APPLICATION NO.	FILING DATE	FIRST NAMED INVENTOR	ATTORNEY DOCKET NO.	CONFIRMATION NO.
10/591,946	11/30/2006	Stephan Oberle	27634U	6433
²⁰⁵²⁹ THE NATH LA	7590 08/18/201 AW GROUP	EXAMINER		
112 South West	Street	YABUT, DANIEL D		
Alexandria, VA 22314			ART UNIT	PAPER NUMBER
			3656	
			MAIL DATE	DELIVERY MODE
			08/18/2010	PAPER

DETAILED ACTION

1. Claims 1-5, 9, 12-14, 16, 17 and 19 are rejected under 35 U.S.C. 103(a) as being unpatentable over Korean PG Pub KR20020046534 in view of Berlinger, Jr. et al., US Patent, 6,101,892.

Figure Y: View of tooth flanks of Berlinger Jr. et al.

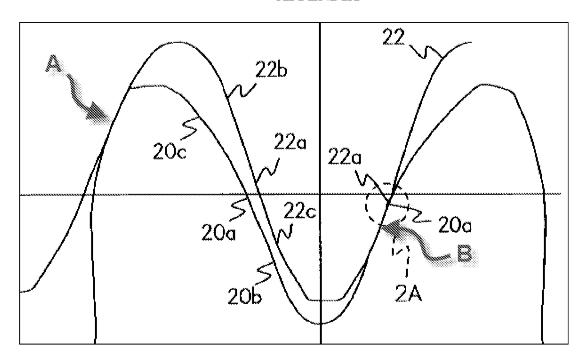
- First (5) toothed gear wheel made of plastic (English abstract / L6-9).
- Second gear wheel (4) with tooth flanks (at 5 and 4, respectively) meshing with each other (abstract / L7-9).
- Tooth flanks of said toothed gear wheels having an involute-free mesh profile in the force transmission area (C4 / L60-65; Berlinger Jr et al.).
- Transition from a concave area directly to a convex area (C4 / L56-58, C5 / L7-14;
 Berlinger Jr. et al.)
- Effective profiles of said tooth flanks matching in a manner that it comes to planiform contact regions (C4 / L60-65; see planiform contact regions at A and B in Fig. Y below Berlinger Jr. et al.), linearly vied in cross section, along their complete height (Fig. 2).

- Effective profiles of the tooth flanks coordinated with each other over their entire
 height, thereby establishing said planiform contact regions, linearly viewed in cross
 section, along their complete height.
- Fransition from the concave area directly to the convex area provides a direct change from a concave to a convex curve in transition zones with no involute transition area (C4 / L56-58, C5 / L7-14; Berlinger Jr. et al.), thereby reducing development of noise during meshing (C1 / L29-40, C5 / L59-64), and achieving a high bearing and loading capability over an entire rolling contact zone resulting from the meshing of teeth (C5 / L59-64).
